Overview: Production error in version 1.0 harnesses; The immobilizer wire (orange/black) is in pin position #4 instead of pin position #5. Although an effort to correct the issue was made, some quantity of harnesses did get shipped before the issue was spotted. We are advising to inspect the harness BLADE connector before attempting to install harness or program the module. This issue is not known to affect the version 2 harnesses, which require no modification.

MODIFICACIÓN REQUERIDA PARA APLICACIONES A/T, SÓLO CON ARNÉS v 1.0

FTI-STP1: Notas de preparación y cobertura del vehículo

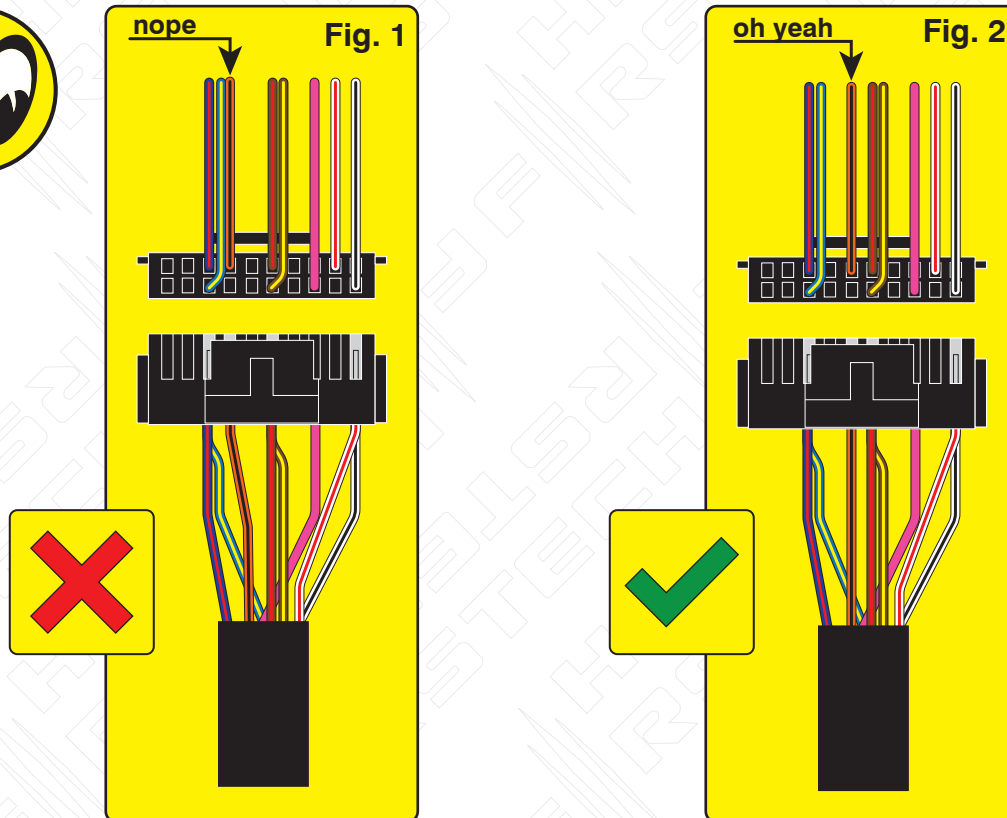
Issue: Module fails to program correctly to vehicle, does not allow the vehicle to be remote started.

Correction: Step 1.) Locate the orange/black wire and confirm whether it is positioned as illustrated in Fig. 1 or Fig. 2. If the wire is as illustrated in Fig.1, proceed with Step 2 through 5 and complete the repair procedure outlined, if the wire is as illustrated in Fig. 2, correction is not necessary, proceed with harness installation and module programming.

Step 2.) Using a pick, lightly depress the catch that secures the terminal in the housing then remove the wire and terminal from the housing.

Step 3.) Using a fine tip razor or utility knife, insert the blade beneath the terminal catch and raise it slightly, so that it can be reused to secure the terminal when reinserted into the BLADE connector housing.

Step 4.) Refer to Fig. 2 for correct position of the orange/black wire (next to brown/red) then reinsert the terminal, pressing lightly until the catch 'snaps' into place, securing the terminal in the connector housing.

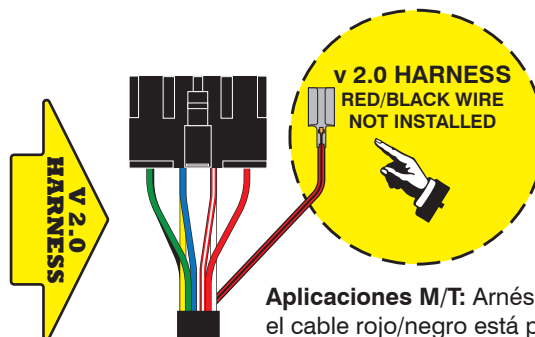
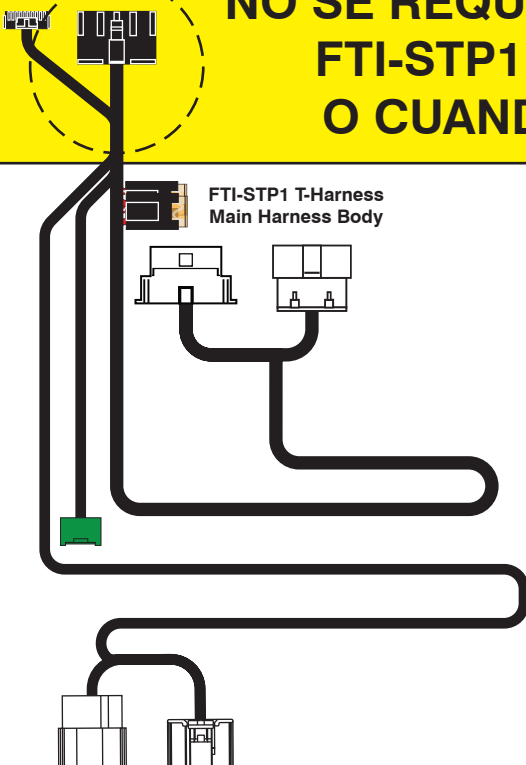
Descripción general: Las primeras versiones del arnés FTI-STP1 requieren modificaciones para aplicaciones de transmisión automática (AT), algunas del producto se pudo modificar antes del lanzamiento, pero una pequeña cantidad se lanzó sin modificaciones.

Problema: El arnés en T FTI-STP1 ha sido diseñado para ser compatible con A/T (transmisión automática) y M/T (manual), pero debido a un descuido en las primeras ejecuciones de producción, la selección se estableció por defecto en el modo M/T.

El uso de un arnés configurado para una aplicación M/T, en un vehículo equipado con A/T, podría provocar daños en el módulo del vehículo, se recomienda que el arnés vuelva al modo A/T antes de la instalación en vehículos equipados con transmisión automática.

Corrección: Localice el cable rojo/negro (+ embrague) proporcionado en el conector CN1 del conjunto del arnés principal. Corte el cable rojo/negro, ya sea al ras del conector CN1 o dejando suficiente cable expuesto para que pueda aislar y asegure los extremos del cable que quedan después del corte. Aísle cada uno de los extremos restantes del cable rojo/negro y asegúrelos para evitar cualquier posibilidad de cortocircuito. Si el cable rojo/negro ya ha sido desconectado, ninguna modificación adicional se requiere para aplicaciones A/T

NO SE REQUIERE MODIFICACIÓN CUANDO SE UTILIZA FTI-STP1 (v 1.0) ARNÉS EN APLICACIONES M/T, O CUANDO UTILICE EL ARNÉS FTI-STP1 (v 2.0)

Aplicaciones M/T: Arnés versión 2.0, el cable rojo/negro está pegado al arnés principal cuando se envía, y debe instalarse en el CN1 conector cuando está instalado.

Aplicaciones A/T: Deje el cable rojo/negro pegado al arnés, no es necesario para aplicaciones A/T
